NEWMAR CORPORATION

TECHNICAL SERVICE BULLETIN

TSB #
193

TSB #991111-01

Figure 4 - Air Spring Upper Mount

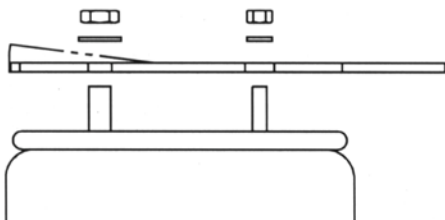
1. Disconnect the airline at the air spring and remove the connection fitting.
2. Remove the nuts and washers from the upper air spring mount studs. See Figure 4.
3. Remove the bolts that secure the air spring to the lower control arm. See Figure 5.
4. Remove the air spring.

1. Assemble the air spring to the lower control arm using three 700137-01 (HHB M12-1.75 x 110mm). Tighten the bolts to **30-40 lb. • ft.**
2. Assemble the nuts and washers that connect the air spring to the upper air spring mount on the subframe. Tighten the nuts to **30-40 lb. • ft.**
3. Install the connection fitting into the air spring. Use Permatex or equivalent thread sealant.
4. Connect the airline to the air spring.
5. Lower the vehicle frame and inflate the air springs.
6. Check the air fittings for leaks.
